# Chapter 8 – Marine Environmental Quality

AAP01-000-GEG-GGEN-00002

**Figure 8-3: Sandwave Dredging Areas 1-5, 17-20 and Potential Spoil Disposal Grounds A, B, C and D**

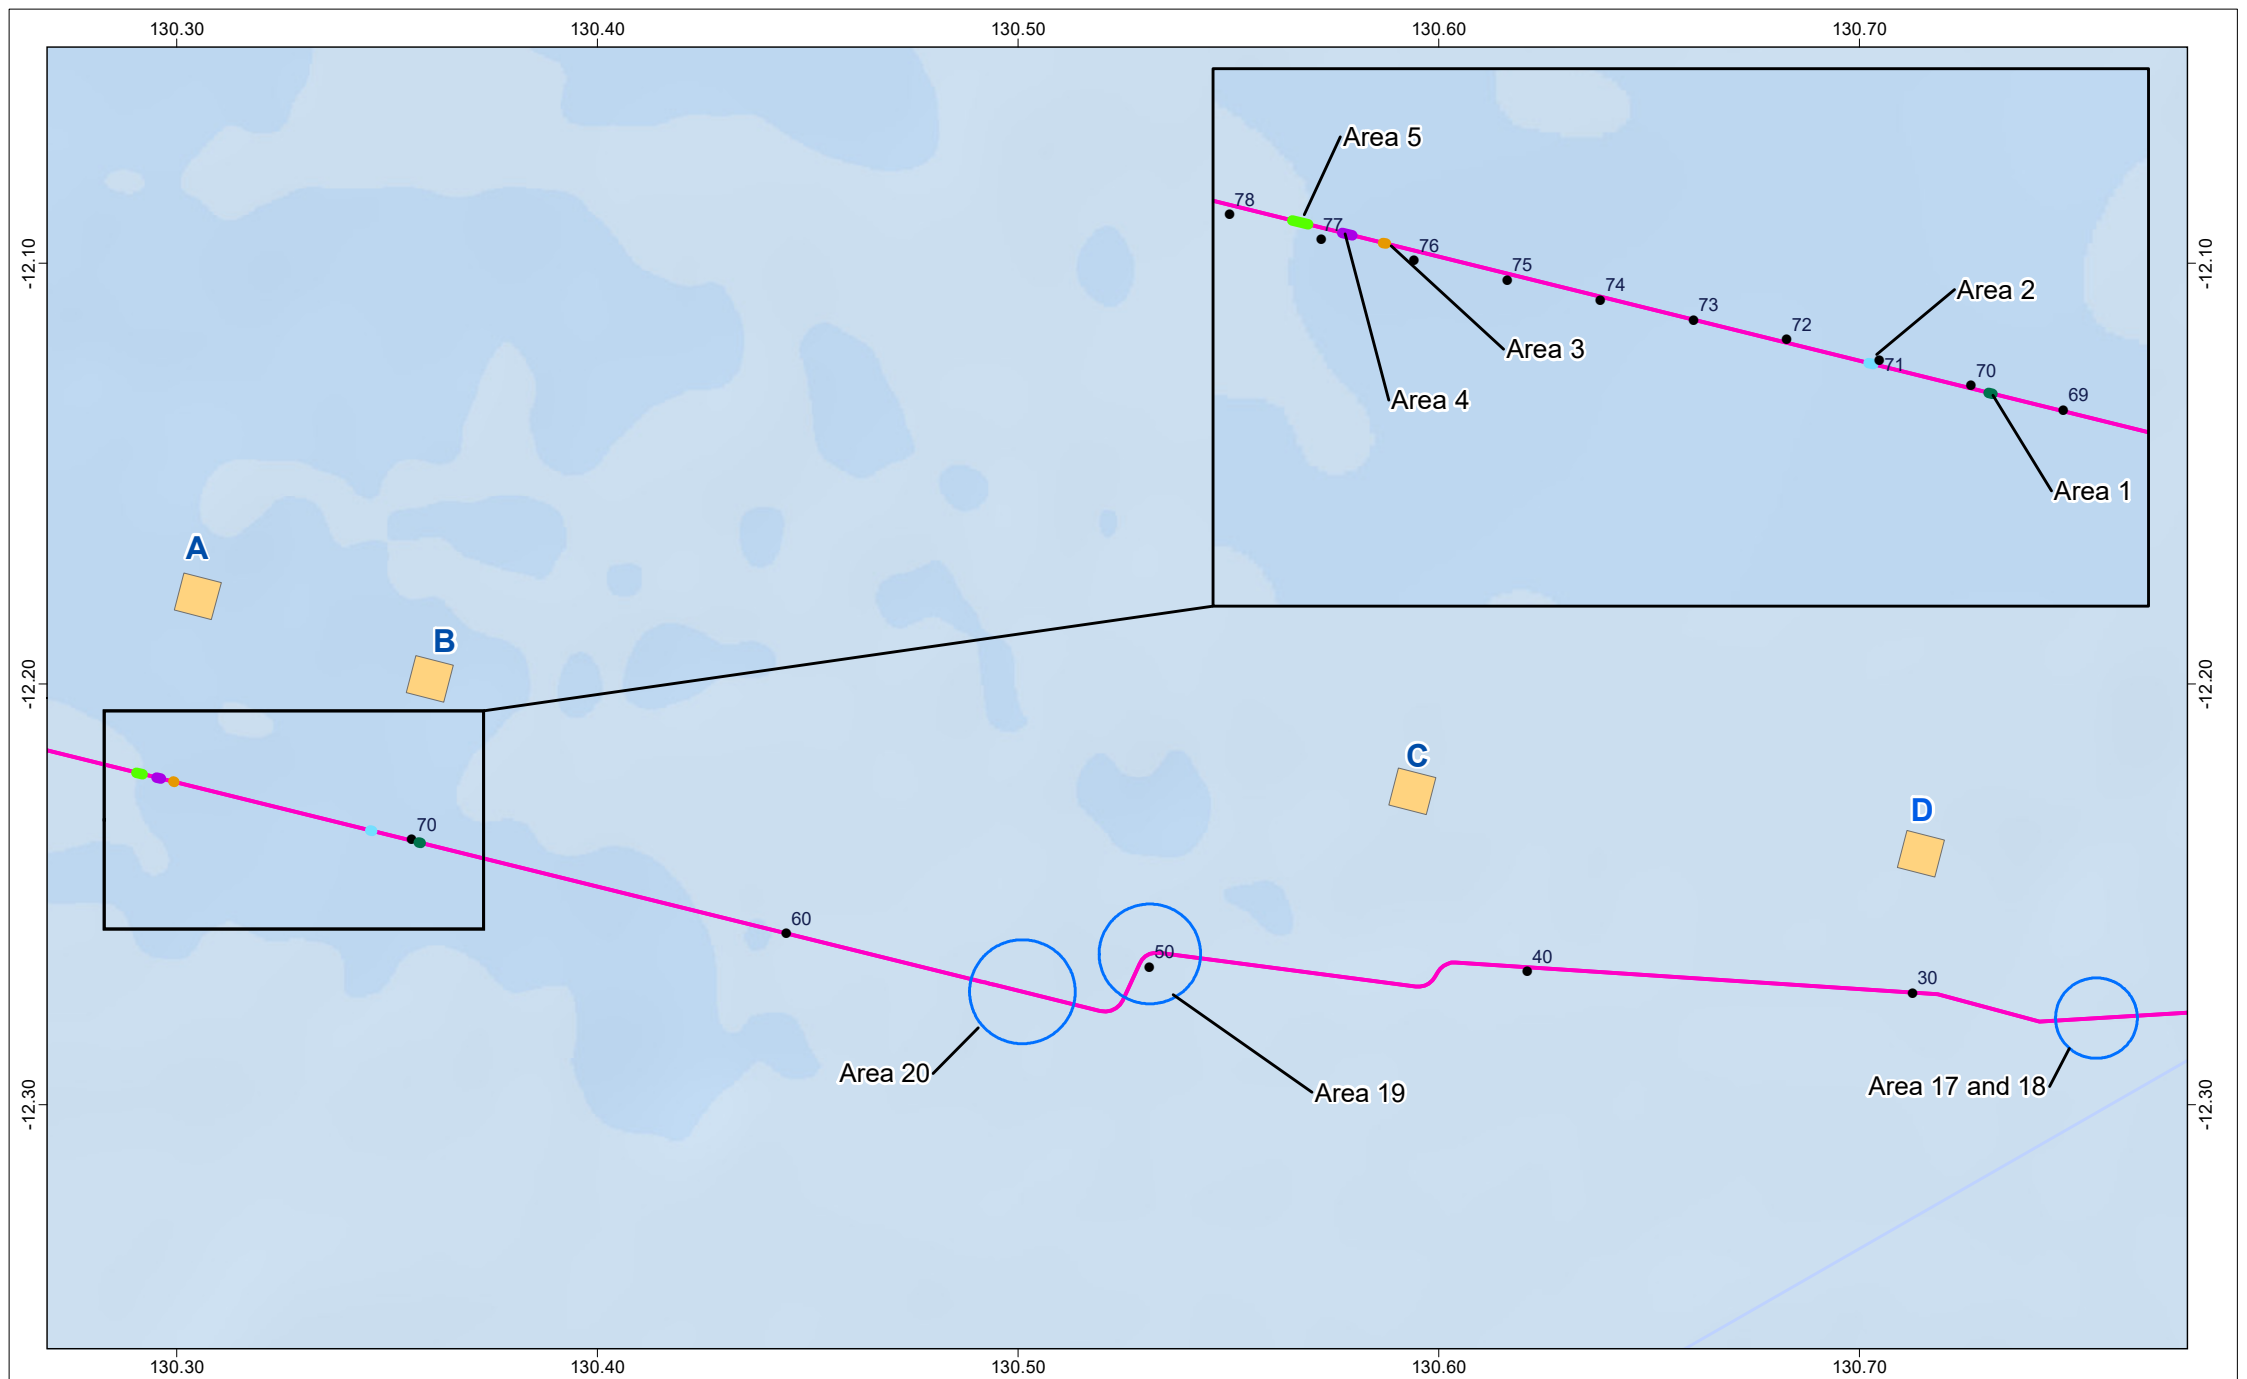
*Provide information required in a dredge and dredge spoil placement management plan including:*

Section 8.3.2 details the sand waves and potential spoil disposal grounds and Figure 8-3 details the location of sand wave removal and potential spoil disposal grounds.
